**S72 Amendment & Submission for Endorsement
Permit PA2504015 (2-6 Lampard Road, Drouin)**

Submission for Endorsement & S72 Amendment (Permit PA2504015)

1 Overview and Assessment of Proposed Plan Amendments

Figure 1. Decision plans (left) and current proposed amendment (right)

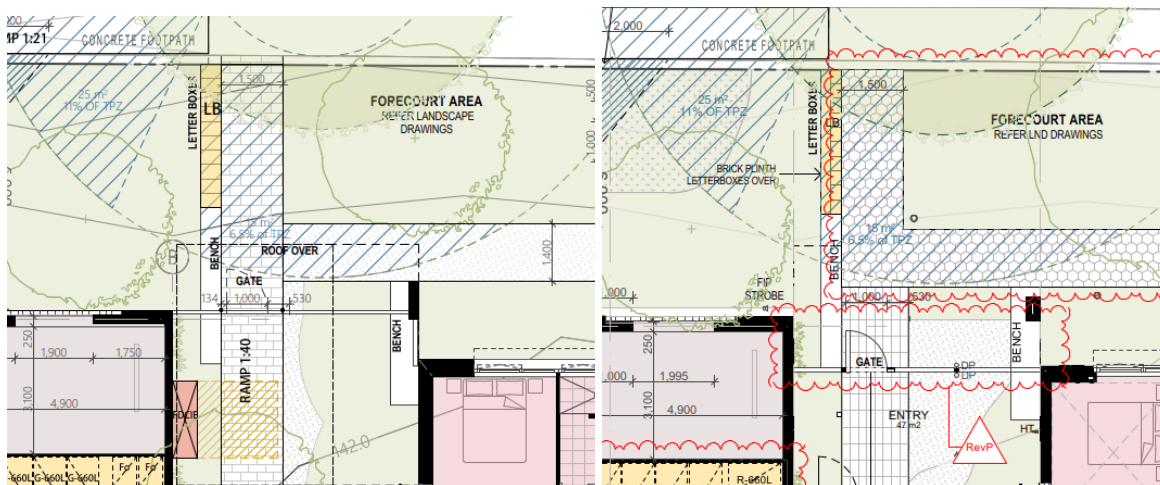
1. Relocation of the main entry gate to the apartment buildings along the northern frontage to be set back further south (aligned with the east wing of the apartment).

This change has resulted from further detailed design review and to reduce the visual impact of the fence and gate from the street.

This change is appropriate given it results in a net improvement to the presentation of the street frontage by recessing the fence and gate further back.

Figure 3. Decision plans (left) and current proposed amendment (right)

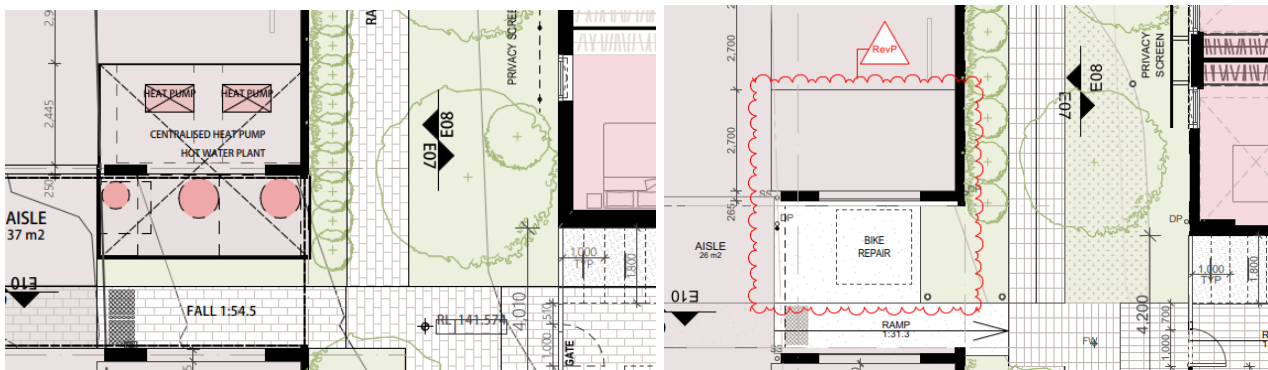
3. Relocation of the hot water plant room and bike repair area and subsequent increase in number of resident car parking spaces (increase of 1 space from 27 to 28 spaces).

This change has occurred following a review of service requirements which confirmed that less space is required for services.

The change is appropriate given there is no maximum car parking rate for this site. The relocation of the bike repair area is also a net improvement for residents as it provides more space to the central E-W pedestrian link through the eastern wing of the apartment building.

Figure 4. Decision plans (left) and current proposed amendment (right).

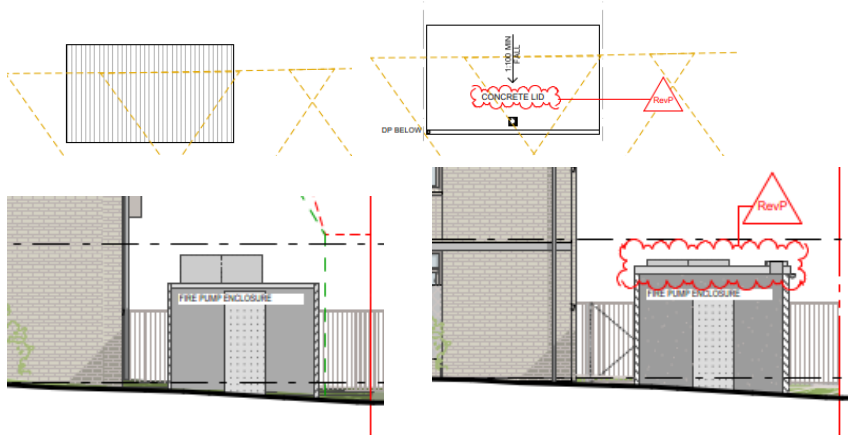
4. Modification to fire pump enclosure, including increase in height (200mm higher) and change in materiality to solid render to allow for a fire-rated concrete lid.

This change has occurred following a review of services and fire engineering requirements. The location of the enclosure remains unchanged.

The change is appropriate given the increase in the height of the fire pump enclosure is very minor and the footprint of the structure remains unchanged. The change will not affect the amenity of the adjacent dwelling to the south, noting the enclosure remains within the building envelope identified in Standard B4-2.1 (north-facing windows).

Figure 5. Decision plans (left) and current proposed amendment (right).

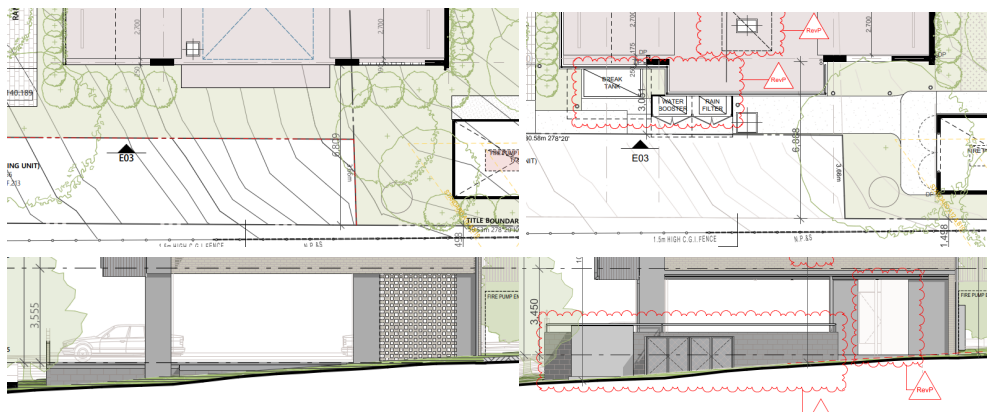
5. Relocation of building services to the south of the car park area at ground level (rain filter, water booster, break tank) and removal of the hit-and-miss brick to the southern façade of the west wing of the apartment building.

This change is the result of detailed services and design review.

The change to the services is appropriate given the services continue to be located away from the public realm and are separated from neighbouring lots through setbacks and are enclosed. The services are also of a low height and will be hidden behind boundary fencing.

The removal of the hit-and-miss brick feature is a minor change and has a negligible impact on the presentation of the building from the surrounding land.

Figure 7. Decision plans (left) and current proposed amendment (right)

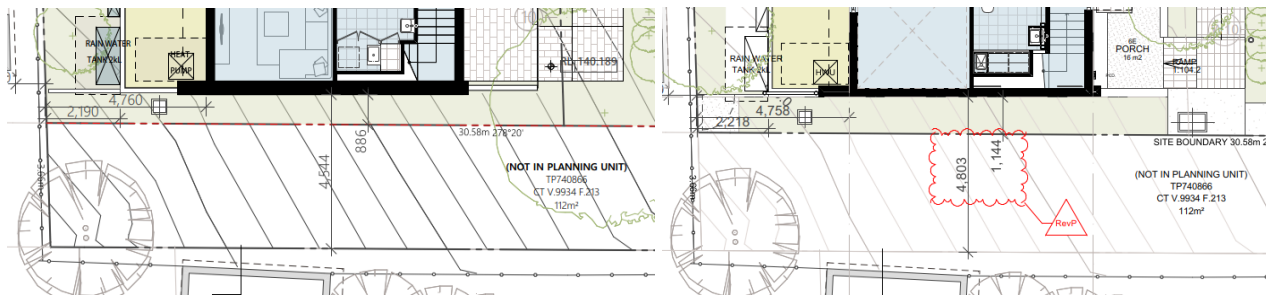
7. Increase to the setback of the southern townhouse building from southern boundary from 4.5m to 4.8m.

This change is the result of changes in wall thickness arising from the detailed design review process.

This change is appropriate and results in a net improvement for the adjacent land to the south as it increases separation of built form from neighbouring lots.

Figure 9. Extract of B4-2.2 Standard noting the 6m setback allowance from the southern boundary line.

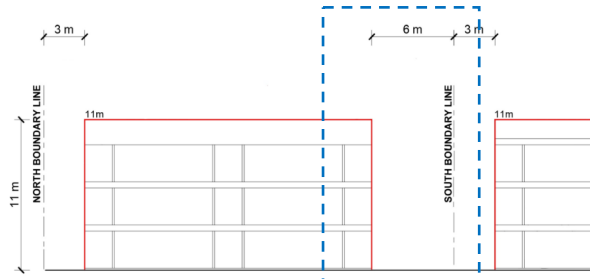
- All wall heights within 3m of the existing north-facing windows to the south will be less than 11 metres above NGL. This complies with Setback Option B4-2.2 (north facing windows) in Clause 55, which allows a 6m setback from the southern boundary up to a height of 11m for new buildings that also meet the setback requirements in Standard B2-3.2 (side and rear setbacks). Refer extract of B4-2.2 below.

The southern setback of the eastern apartment building complies with the building envelope in Standard B2-3.2 (and would also comply with the setbacks in Standard B2-3.1). Therefore, the adjustment to the roof form remains aligned with the requirements of the Standard and continues to respect the existing dwelling to the south.

Figure 11. Decision plans (left) and proposed plans (right) showing updates to communal area design.

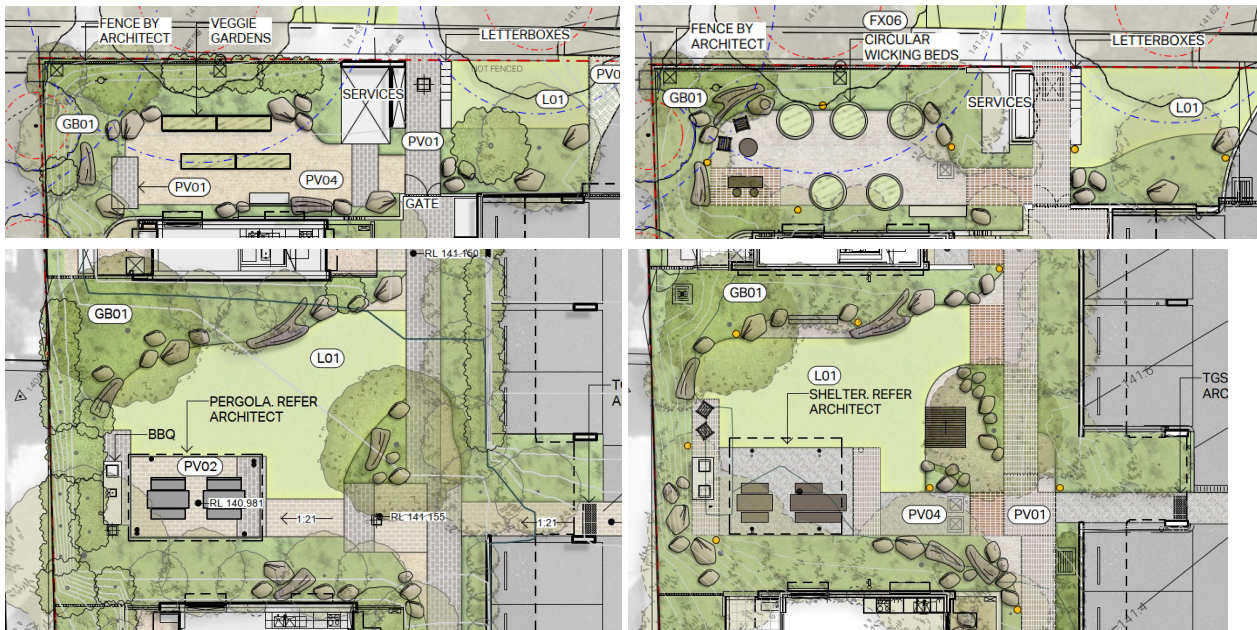
- Adjustments to the design and layout of seating, garden beds and other furniture in the communal areas along Lampard Road and between the townhouses.

This change is the result of detailed design processes and a refinement of construction details.

Figure 12. Decision plans (left) and proposed plans (right) showing changes to Main South Road interface.

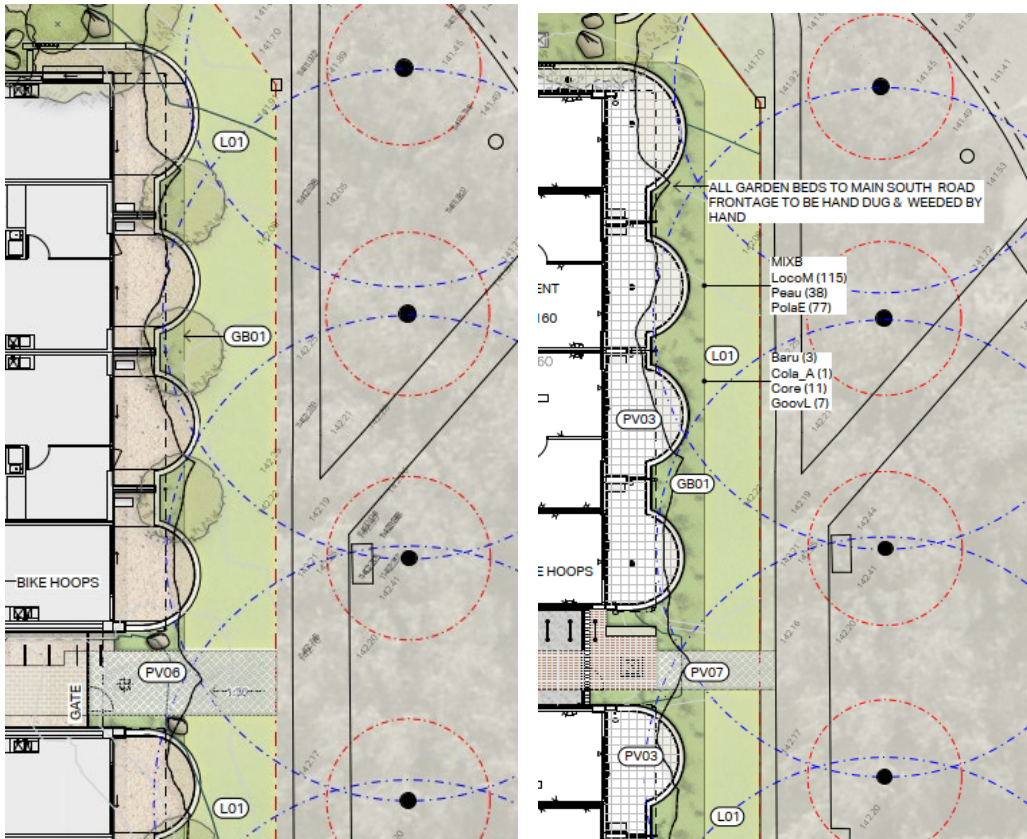
- Removal of trees along the eastern Main South Road interface and replacement with low level planting and shrubs in the expanded garden beds in front of the balconies.

The removal of trees from the east interface was informed by detailed design review and advice from the arborist to avoid competition and potential conflicts with the existing heritage trees and retained canopy along Main South Road. Shrub and dense low-level planting has been selected for the eastern garden beds to provide softening and visual relief between the curved brick balconies, and to provide additional low-level layers of greenery that addresses permit condition requirements.

The reduction in tree planting along this interface is appropriate given the revised landscape design continues to deliver generous areas of total tree canopy across the site from retained and newly planted trees. Refer below for further discussion about canopy cover. The design includes 2m and 3m high shrubs which will retain structural diversity in the planting along this interface and add visual interest and softening to the streetscape.

The change also remains consistent with permit condition 5(d) to provide additional lower-level planting in the east setback to Main South Road, as the plans now provide for a larger garden bed area in front of the balconies with a larger number of plants compared to the decision plans.

Figure 13. Decision plans (left) and proposed plans (right) showing revised canopy tree planting

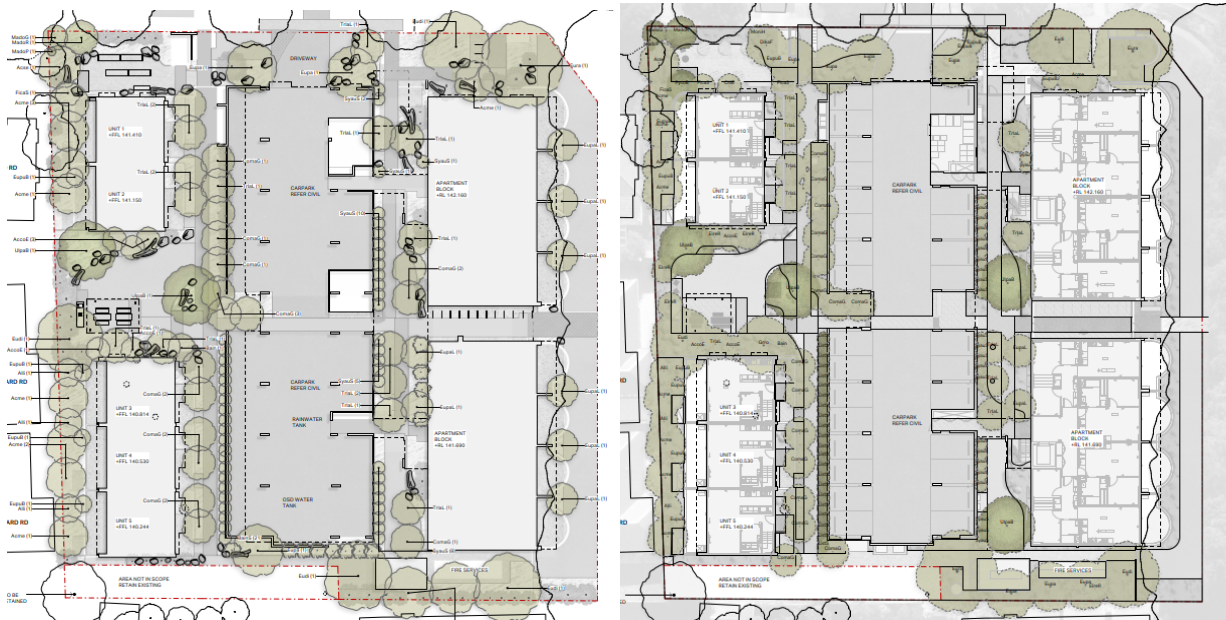
- Adjustments to new canopy tree planting.

This change has occurred following architectural and landscape detailed design processes to reflect the other changes discussed above. It results in the following changes in canopy tree provision:

- The revised landscape plan results in a very minor reduction in total canopy cover and continues to provide total canopy cover over 20% through retained and new trees.
- The removal of canopy trees along the east interface was informed by arborist advice to avoid potential conflicts and competition with retained high value heritage trees along Main South Road.
- The reduction in trees has only affected the number of small trees on the site; the number of medium (Type B) trees has increased (from 5 to 6 trees).

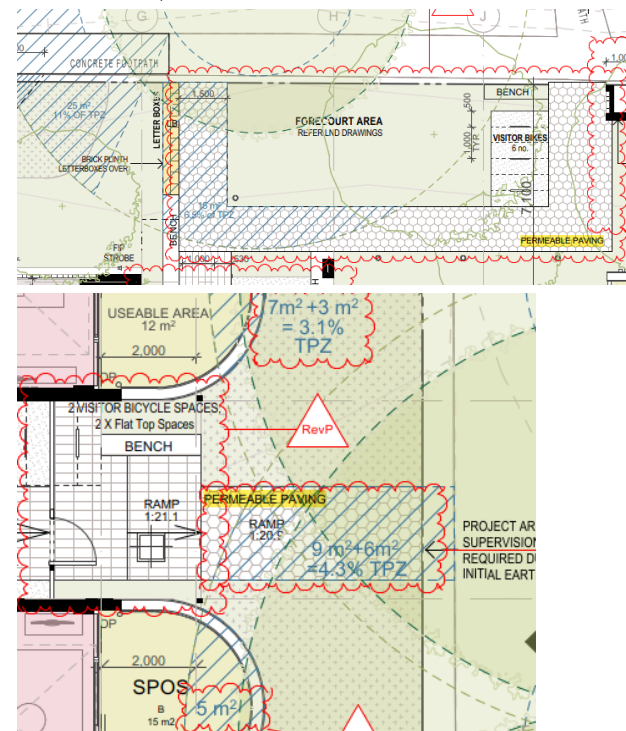
a) The balcony balustrade and roof materials clearly identified on the plans and the materials and finishes schedule.	Balcony balustrade and screening materials are updated and confirmed on elevations and in the material schedule, and roof materials have been added into the material schedule and confirmed on roof plans. Refer extracts below. BALUSTRADE & SCREENS FC Sheet, Composite Coloured & Perforated Metal  METAL ROOFING Zincalume profiled roof sheeting

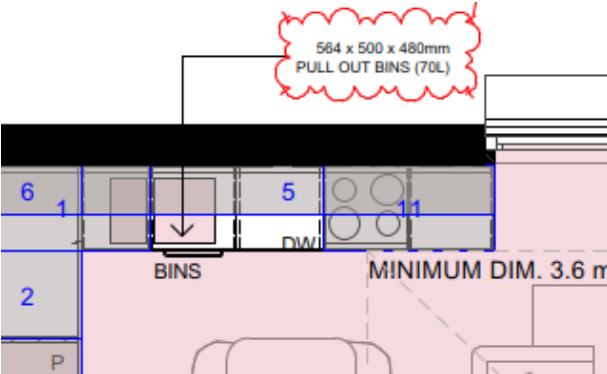
e) Minimum 0.07 cubic metres internal waste storage areas within each dwelling in accordance with Standard B5-5 (Waste and recycling)

All dwelling floor plans have been updated to confirm compliant internal waste storage areas in line with the Standard. Refer to the example extract below.

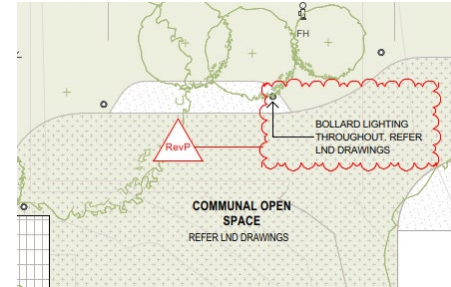
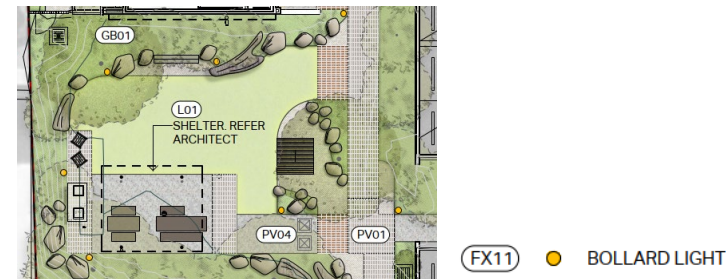
f) Lighting details to all outdoor common areas including accessways and paths within the site.

Lighting details for outdoor common areas and internal accessways/pathways are confirmed in the architectural and landscape drawings. The architectural plans include a note confirming the presence of bollard lighting as well as a reference to the landscape plans, to comply with this condition. Refer extract below

The landscape plan then also confirms the location of bollard lighting in appropriate areas to ensure safe and comfortable communal spaces whilst minimising excessive light spill. Refer extract below.

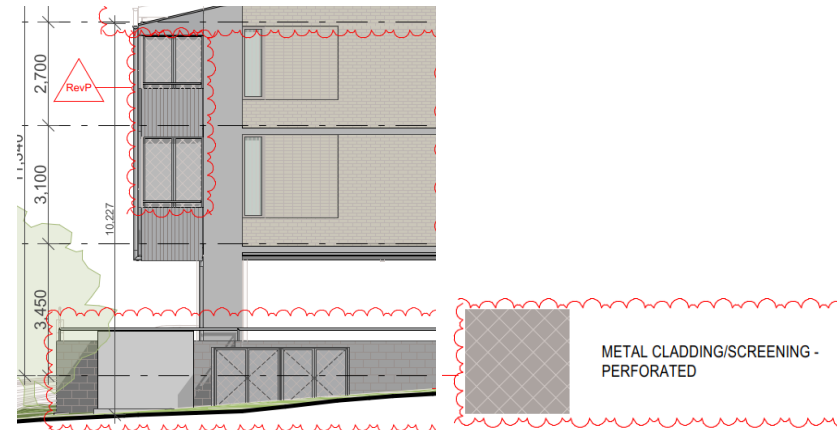
g) The southern edge of the balconies associated with dwelling 109 and 209 altered to comply with Standard B4-3 (Overlooking).

Firstly, we note that the apartment number references have changed; dwelling 109 is now 113 and dwelling 209 is now 213.

Perforated screening has been applied to the southern edge of these balconies in question to limit views to the south in accordance with the overlooking standard at B4-3. This is confirmed in the south elevation on TP204 and in the materials legend. Refer extracts below

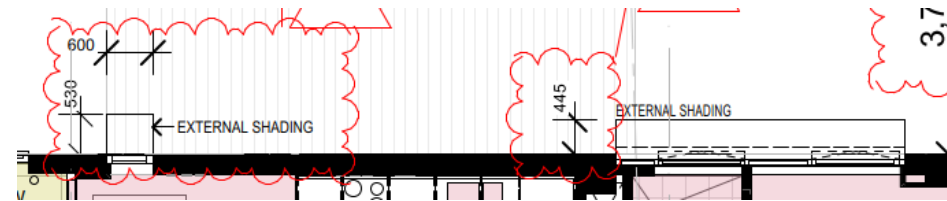
h) External shading devices shown to north-facing upper living windows of dwelling 105, 112, 205 and 212 with of the minimum horizontal depth dimensioned in accordance with Standard B5-4 (Solar protection to new north-facing windows).

Shading devices and horizontal depth dimensions are noted to the dwellings in question in line with the condition. Refer extract below.

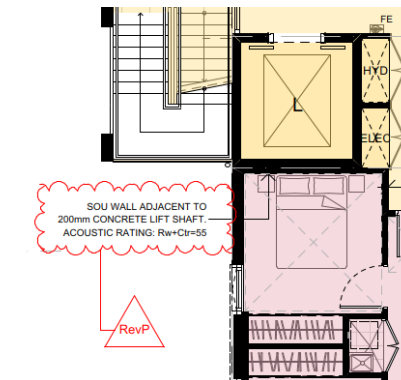
i) Details of the proposed noise attenuation measures to the bedrooms sharing walls with the lift core which demonstrate they have been designed to limit internal noise levels in accordance with Standard B5-6 of Clause 55.05-6.

The updated plans include notations confirming bedroom walls adjacent to the lift cores are constructed to meet appropriate acoustic ratings in line with the standard. Refer extract below.

Figure 15. Decision plans (left) and proposed plans (right) showing increase in garden bed along east interface

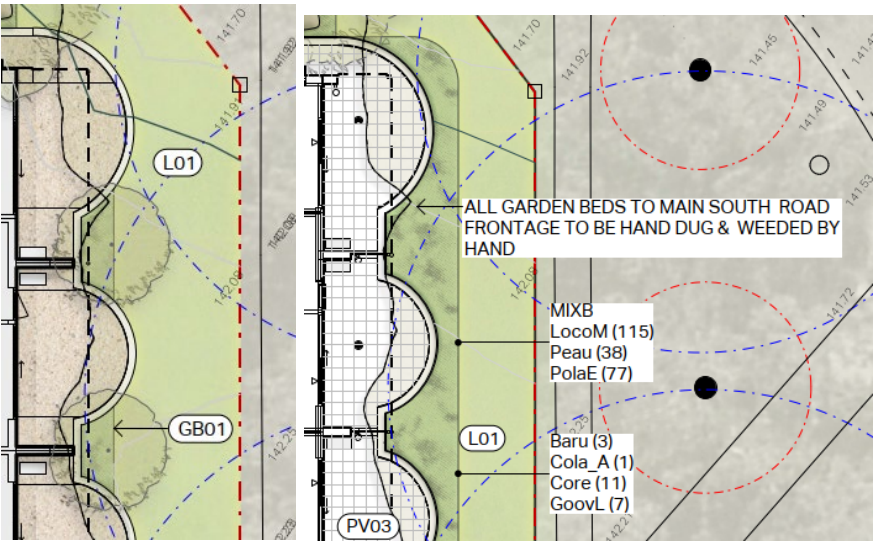
d) Additional lower-level planting in the east setback to Main-South Road.

The landscape plans provide for a larger garden bed along the east interface in front of the residential balconies which provide for more low-level planting than the previous plans, in line with this condition. The plans confirm low-level planting mixes as well as additional shrub planting in the plant schedule. The garden beds will be hand dug and weeded by hand to ensure impacts to heritage trees are avoided; this is confirmed on the plans. Refer extract below.
